PEACH BOTTOM ATOMIC POWER STATION, UNIT NO. 3

AMENDMENT TO FACILITY OPERATING LICENSE

Amendment No. 85  
License No. DPR-56

SAFETY EVALUATION BY THE OFFICE OF NUCLEAR REACTOR REGULATION  
SUPPORTING AMENDMENT NO. 85 TO FACILITY OPERATING LICENSE NO. DPR-56

FIGURE 3.5.K.1 MCPR OPERATING LIMIT vs  $T$

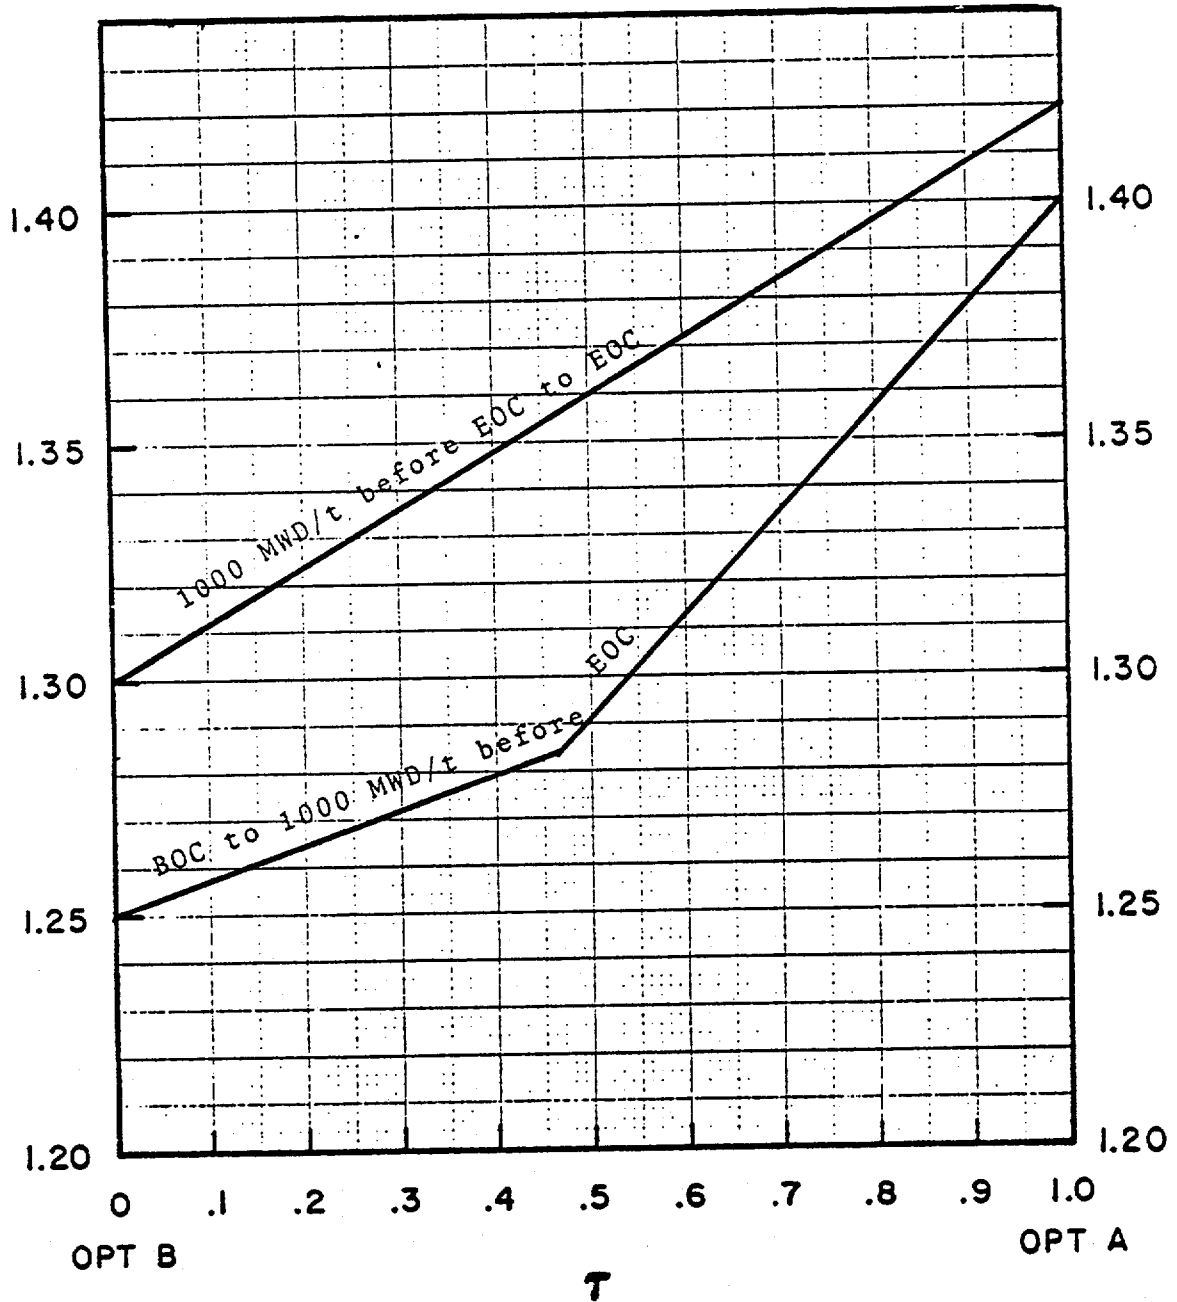
The changes to the TSs amend the minimum critical power ratios during mid-cycle 5 operation of Peach Bottom Unit No. 3. These changes are needed to correct a recently discovered input error to the OLYN transient computer code.

The licensee submitted analytical results (Reference 3) for the pressurization transients using the corrected fuel length input data to the ODYN code. The OLMCPR for option A resulting from the limiting transient, the generator load rejection without bypass transient, is 1.45 for the fuel at end of Cycle 5 (EOC 5) as compared to the original OLMCPR of 1.42 for EOC 5. The difference of 0.03 in CPR reflects the changes in analytical results because of corrections to the ODYN code.

The pressurization transients were also analyzed for the fuel at EOC 5-1000 MWD/t; this represents an increased burnup from the EOC 5-2000 MWD/t given in the original TSs. Section 11 of Reference 3 presents the CPR for both non-pressurization and pressurization transients. The maximum calculated MCPRs in Section 11 are specified as the OLMCPRs and are incorporated in the TSs.

We have reviewed the licensee's proposed changes to the TSs related to the OLMCPR (pages 133d, 133e, 142, 142a) resulting from corrections to the ODYN computer code. We conclude that these changes are acceptable.
